Hi-Performance MerCruiser Tailpipe Change

1999 Model Year Hi-Performance 500 C and 500 Bulldog Engine Packages.

Exhaust Tailpipe Change

- a - Standard Exhaust Pipe, 1998 & Below
- b - Standard Exhaust Pipe, 1999 & Above

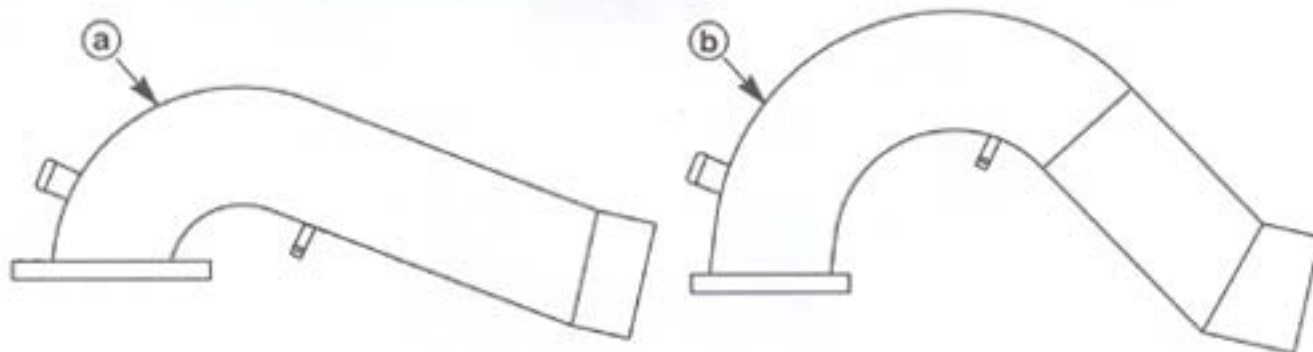
Tailpipes on models listed above will have a higher rise built into the pipe but will exit the transom in the same location as previous tailpipes on Gil/MerCruiser exhausts. Hatch clearance should not be a problem since the top of the pipes do not extend above the flame arrester.

Although the extra pipe rise should help prevent water ingestion/reversion on installations that are marginal in water line to tailpipe height, it is still the responsibility of the installer to test for water ingestion problems. Internal exhaust shutters and external flappers are also required on all Hi-Performance exhaust installations.
